COMPOSITE OF EXPANDORAM II MODIFICATIONS

TECHNICAL BULLETIN NO. 105

EXPANDORAM II

Extensive field usage and further R&D in our engineering department has determined that the ExpandoRAM II could hang up in Wait State Refresh cycles under certain conditions. The modifications delineated below solve this problem:

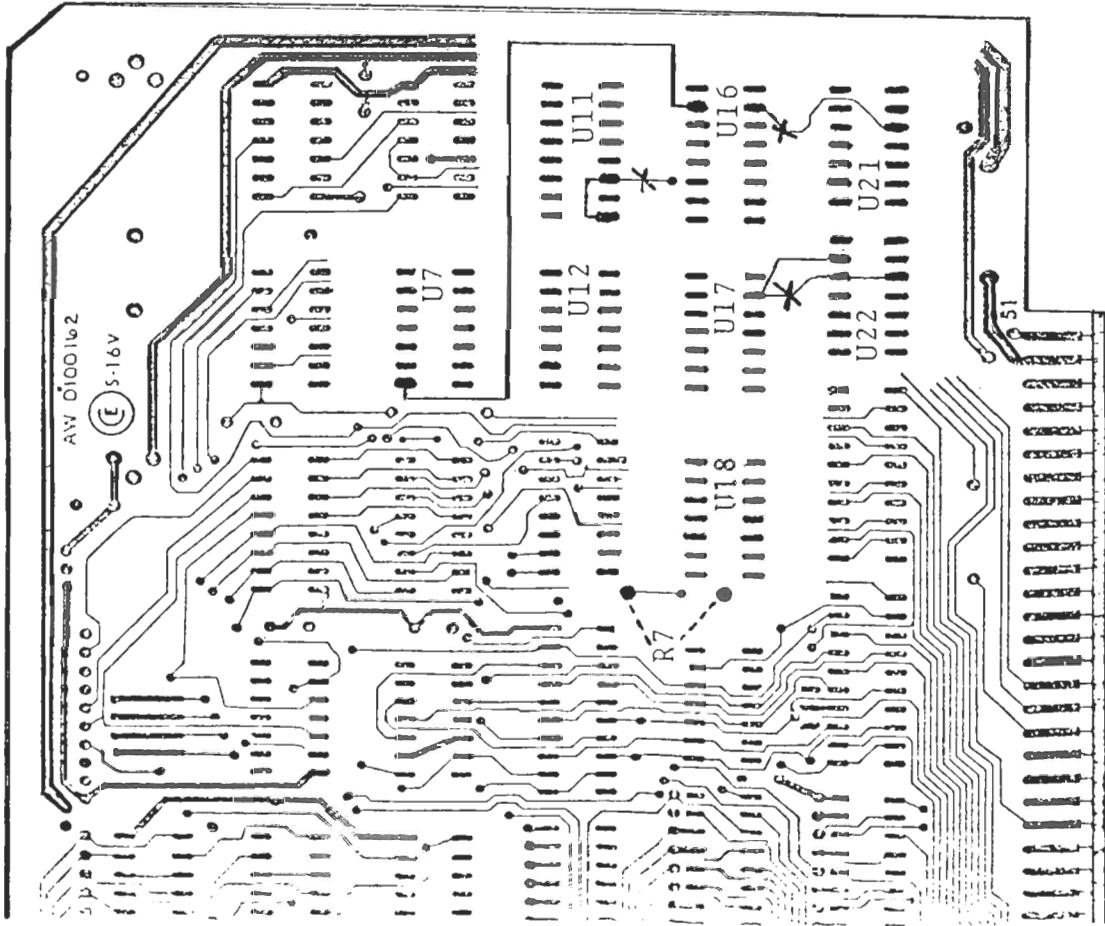
1. Change U6 from 74LS74 (Low-Power Schottky) to 74S74 (Schottky).
2. Change R7 from 10K ohms to 20K ohms.
3. Using the diagram on the back of this page, rework boards to change WAIT STATE REFRESH TIME to leading edge of $\phi 1$.
 - a. Cut etch from U11-14 to U16-7
 - b. Cut etch from U16-10 to U21-10
 - c. Cut etch from U17-9 to U22-5
 - d. Connect an insulated jumper wire from U11-14 to U11-16
 - e. Connect an insulated jumper wire from U7-1 to U16-7
 - f. Connect an insulated jumper wire from U17-9 to U22-6

1. Examine diagram to left and locate the three traces marked with an 'X'. Double check to ensure that you have the correct traces and then cut them with a sharp knife. Make the cut deep and 'v' shaped to make sure that the connection is broken.

2. Locate U7; note the only connection and follow it to U16. Using an insulated wire, complete the connection as shown.
3. Locate U11; note the only connection is a jumper between two pins on U11. Using an insulated wire, complete the connection as shown.

4. Locate U17; note the new connection and follow it to U22. Using an insulated wire, complete the connection as shown.
5. Locate R7 to the left of U18; its solder points are indicated by dotted lines. Remove R7 and replace it with the 20K Ohm resistor provided.

6. Turn your PC board over and locate U6. With a small flat blade screw driver, gently and slowly pry U6 out of its socket. Note the way it is placed in the socket. Using the replacement IC provided, line up all pins with the socket. Be sure that the replacement IC is in the correct position and then push it into the socket firmly. Examine closely making sure no pins were bent.
